# Access Compliance Report

## Public Rights-of-Way

### (Curb Ramps)

Intersection ID: 43986	Main Street: CANYON_CREEK_LN	Cross Street: HOSKINS_RIDGE_LN	Location: SE
ADA ID: E172AEAC34F7	Ramp Type: PerpDiag	Initial Pass/Fail: Fail	Overall Compliance: No
Severity Score: 10			
Codes/Mitigation Info/Possible Solution		Field Measurements/Component Compliance

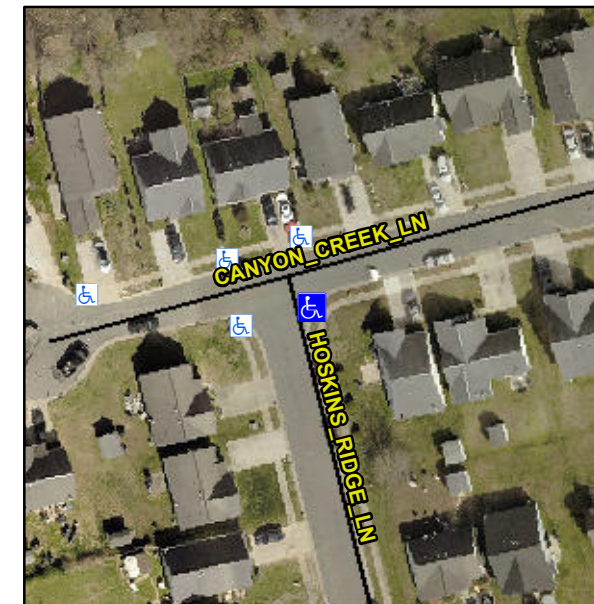
**Remove & Replace Curb Ramp With Two New Directional Ramps or Equivalent.**

**R304.5.1, R304.5.3**

Compliance	Description	Data	Compliance	Description	Data
N/A	Ramp Length (in)	95.5	Yes	Ramp Slope (%)	7.5
No	Ramp Width (in)	38.0	No	Ramp XSlope (%)	2.6
N/A	Flare Type LT	N/A	N/A	Flare Type RT	N/A
N/A	Flare Slope LT (%)	N/A	N/A	Flare Slope RT (%)	N/A
N/A	Flare Traversable LT?	N/A	N/A	Flare Traversable RT?	N/A
N/A	Landing Length (in)	N/A	N/A	DWS Provided?	N/A
N/A	Landing Width (in)	N/A	N/A	DWS Contrast?	N/A
N/A	Landing Slope (%)	N/A	N/A	DWS Length (in)	N/A
N/A	Landing X Slope (%)	N/A	N/A	DWS Full Width?	N/A
N/A	Landing Curb? (Y/N)	N/A	N/A	DWS Offset (in)	N/A
N/A	Shared Landing?	N/A			
N/A	Gutter Ponding?	N/A	N/A	Gutter Slope (%)	N/A
N/A	Gutter Lip Ht (in)	N/A	N/A	Gutter X Slope (%)	N/A
N/A	Painted X Walk1?	No	N/A	Painted X Walk2?	No
	X Walk 1 Direction	To N		X Walk 2 Direction	To W
N/A	X Walk 1 Width (in)	N/A	N/A	X Walk 2 Width (in)	N/A
	X Walk 1 Slope (%)	2.8		X Walk 2 Slope (%)	2.9
	X Walk 1 X Slope (%)	1.4		X Walk 2 X Slope (%)	1.5
